ADDENDUM NO. 3
TO THE CONTRACT DOCUMENTS
for the construction of

Date: September 5, 2014
Project No.: 486753

CHEMICAL SYSTEMS AND ACTUATOR IMPROVEMENTS BID # 913
FAYETTE COUNTY WATER SYSTEM
FAYETTE COUNTY, GEORGIA

DATE	AUGUST 2014
PROJ	486753
DWG	10-C-04
SHEET	of

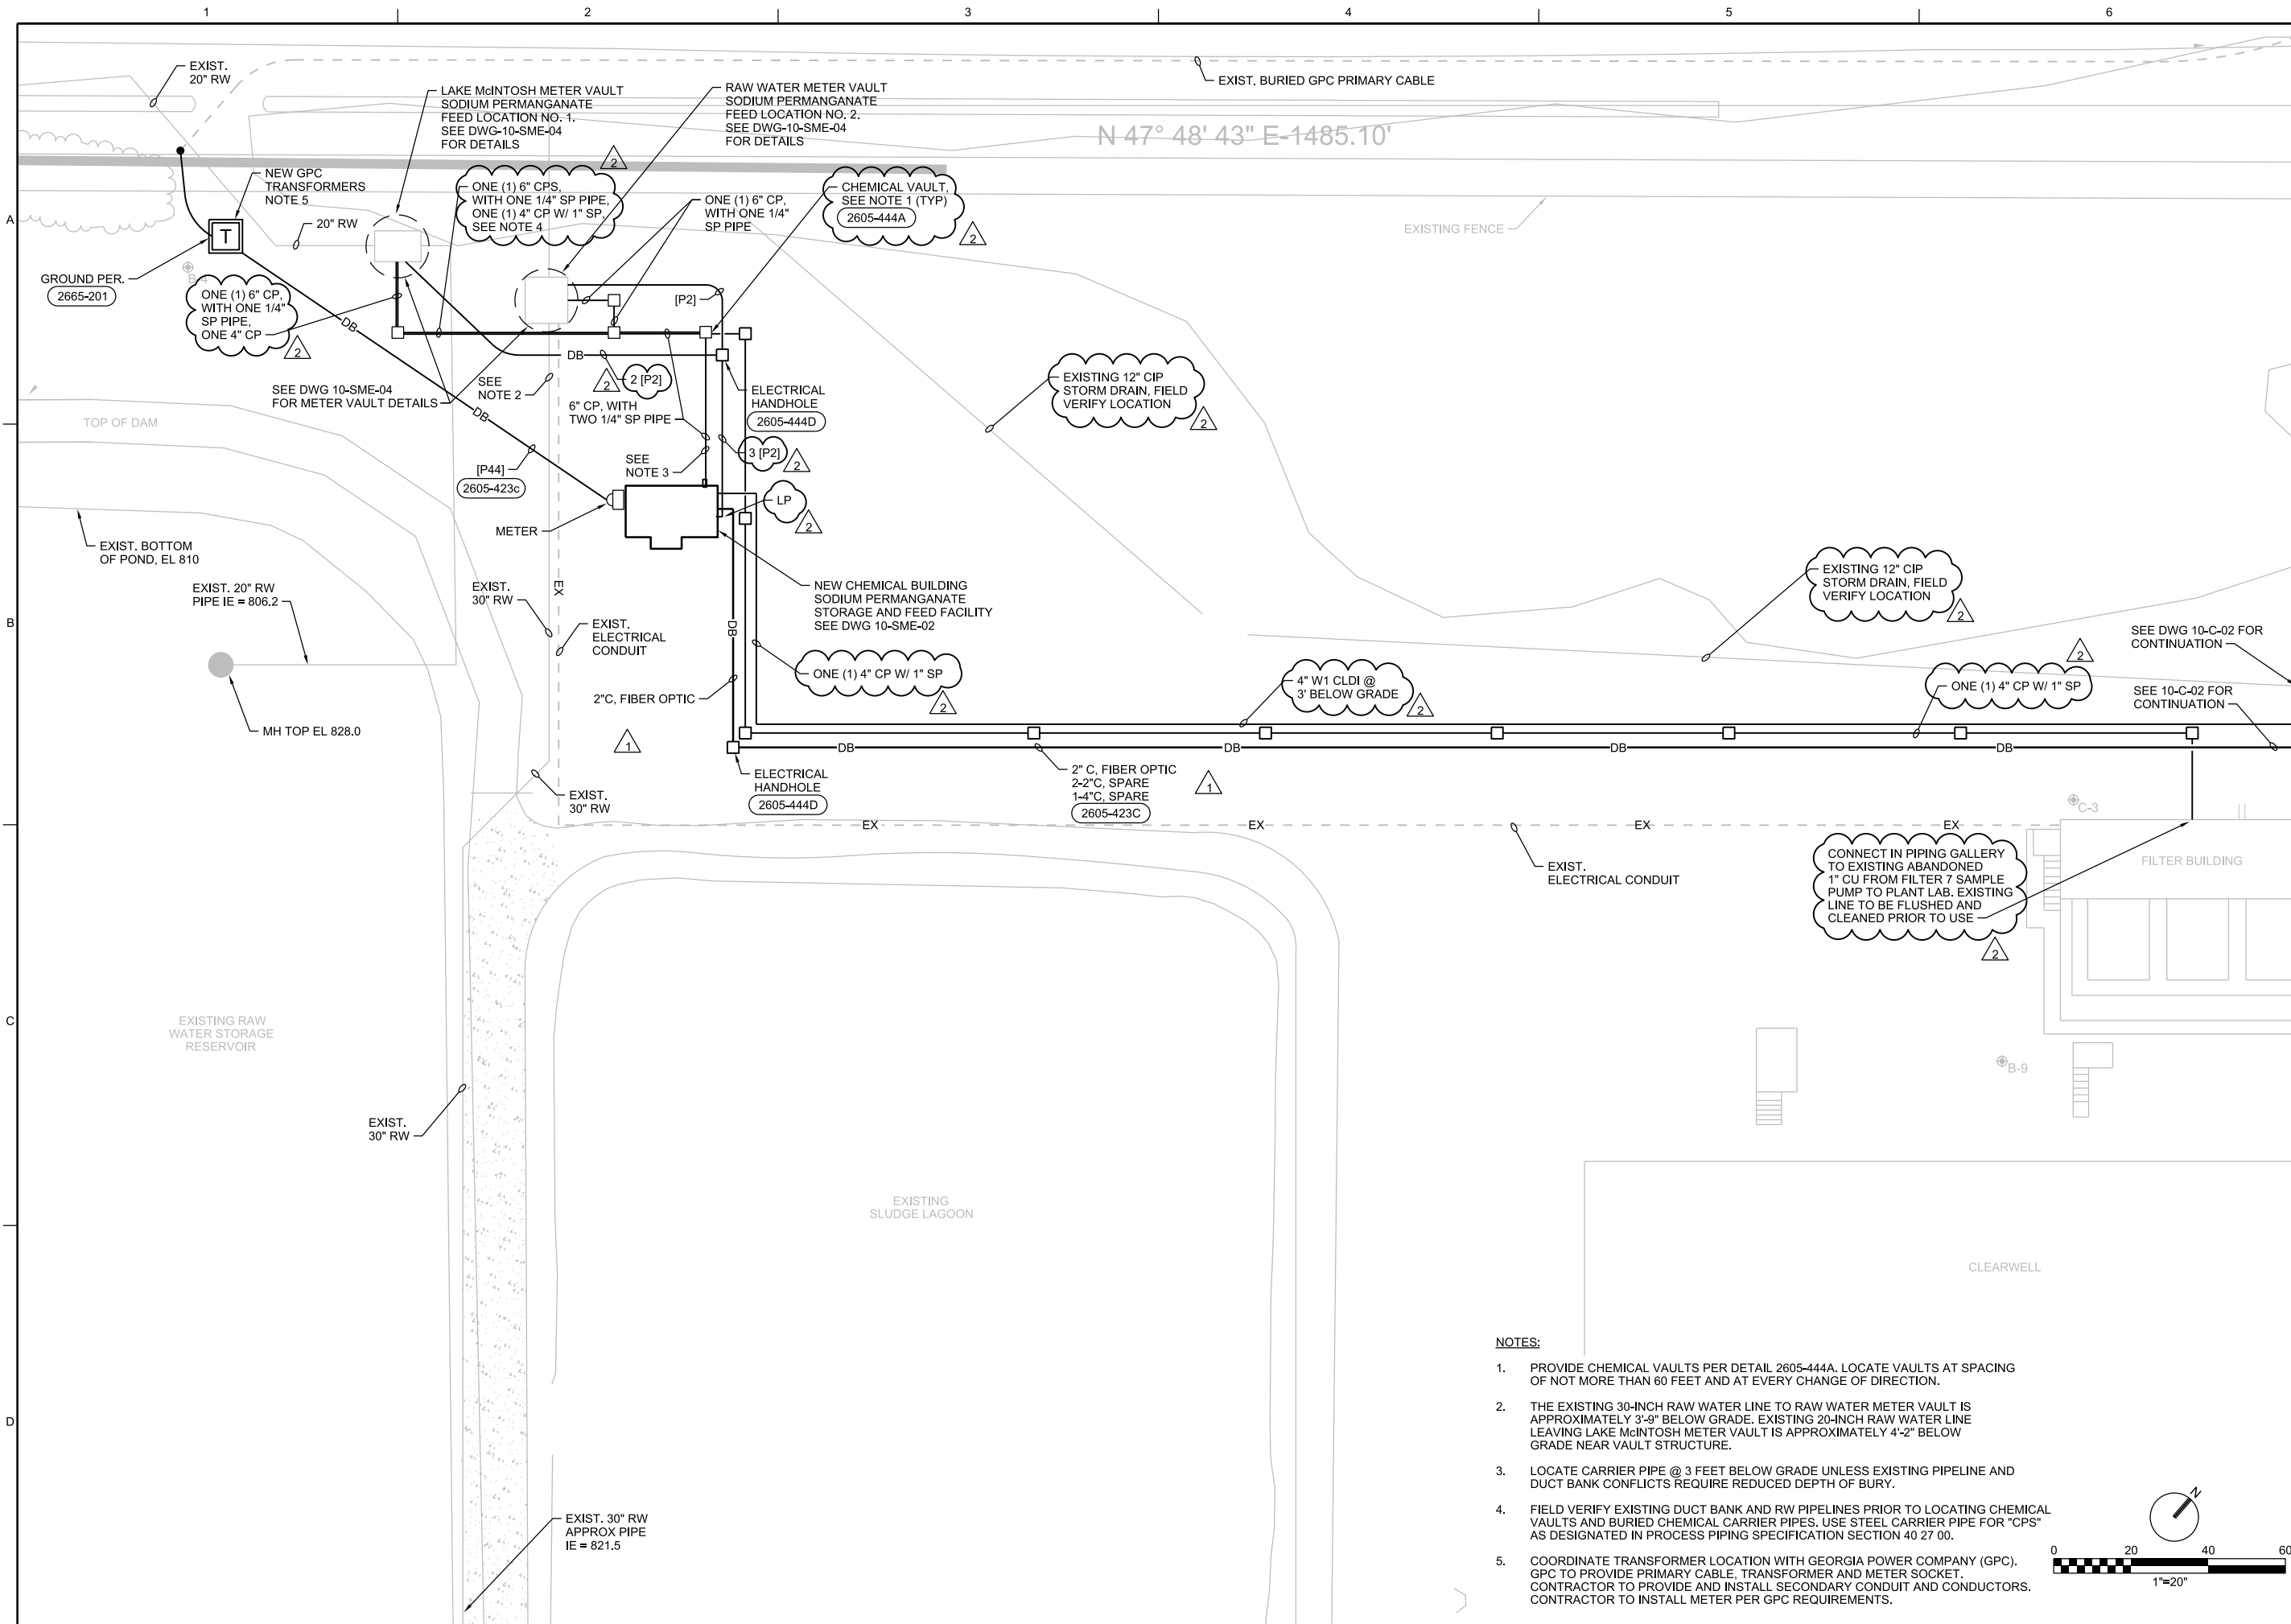
5. Drawing 10-C-04 grid location 3B: Depict a 2” tap with trust block on the 4” W1 near Sodium Permanganate Storage and Feed Facility; add callout “Tap 4” W1. See 4027-640 and 4027-643X.”

CROSSTOWN WTP - ONE LINE DIAGRAM
PANEL SCHEDULE
SODIUM PERMANGANATE BUILDING

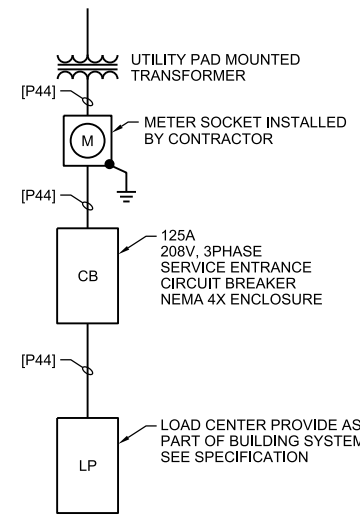
- “1. Three-phase, four wire, 120/208 volts, 60-Hz. Provide UL listed load center in NEMA 3R rain proof and sleet resistant enclosure mounted on exterior of building. Load center shall be provide with 125A main circuit breaker and feeder breakers as shown on Contract Documents. Panel shall power all components provided with enclosure such as water heater, lights, fan, receptacles and HVAC. Provide four GFI receptacles; three interior, one exterior by the doors. In addition feeder breakers are provided for process equipment mounted in enclosure as shown on Contract Documents. Where indicated on panel schedule in Contract Documents, provide Equipment Ground Fault Interrupter (EGFI) rated breakers. EGFI breakers have ground fault sensor and rated to trip on 30 mA ground fault (UL listed for equipment ground fault protection).”

DWG 10-SME-04

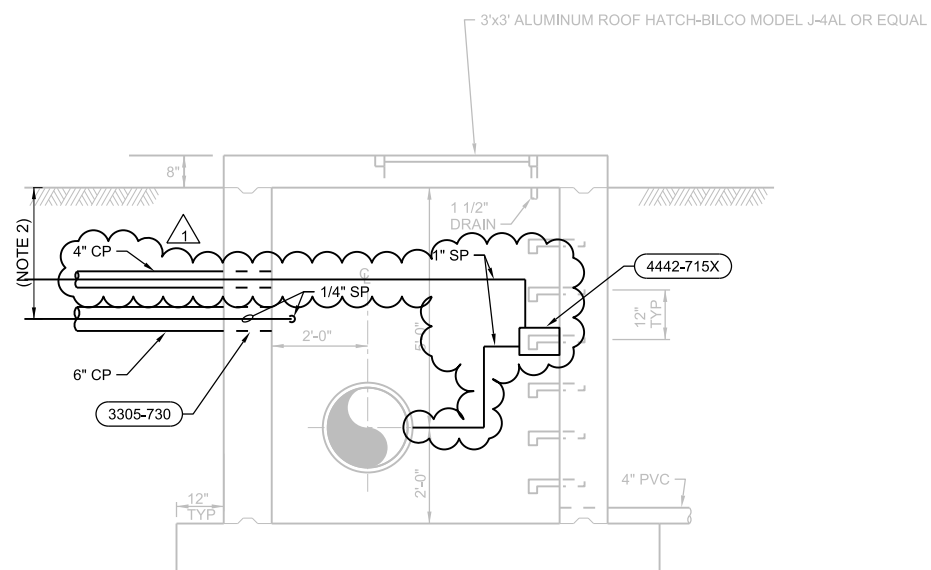
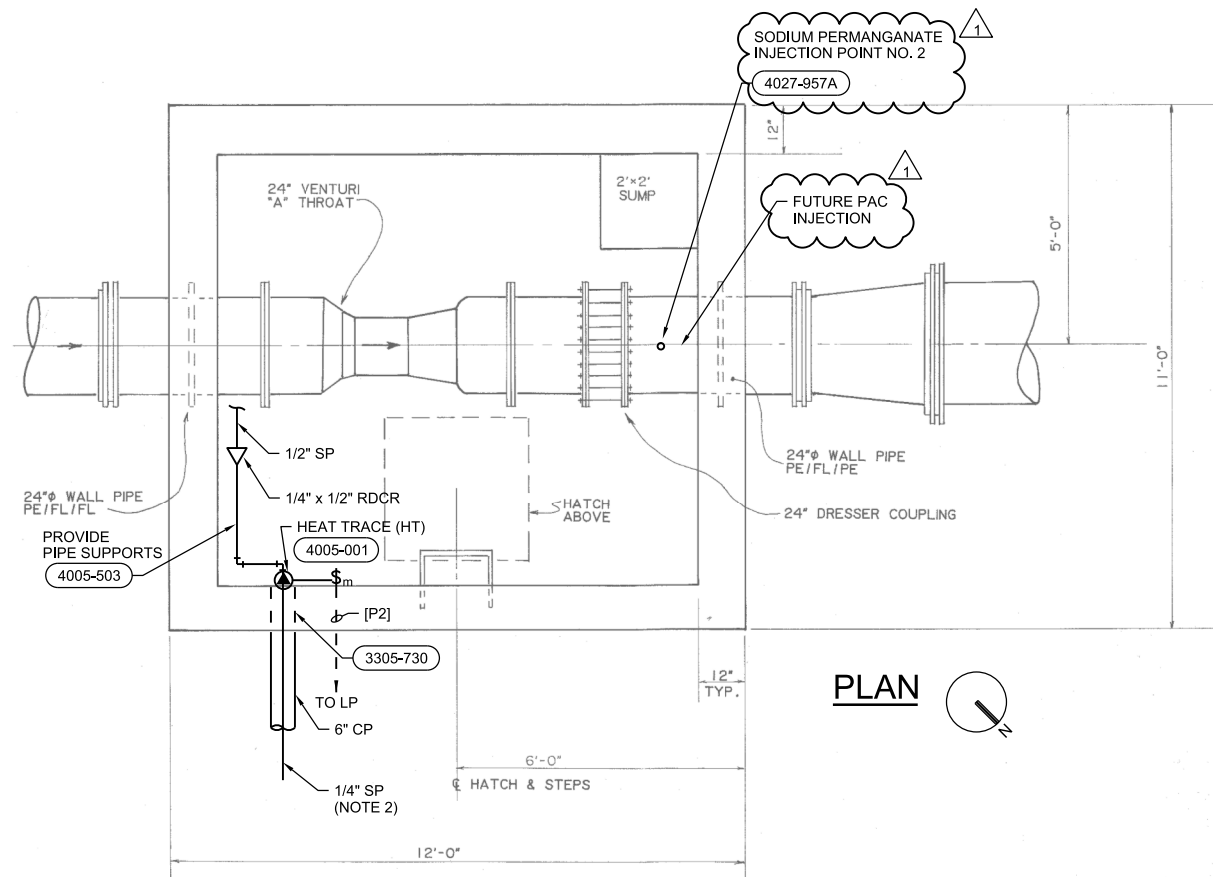
9. Drawing 10-SME-04 Lake McIntosh Meter Vault: Add callout “Sodium Permanganate Injection Point No. 1” near the future pac injection; add note “3. Relocate magmeter downstream for installation of flanged spool section for sodium permanganate and pac injection taps.”
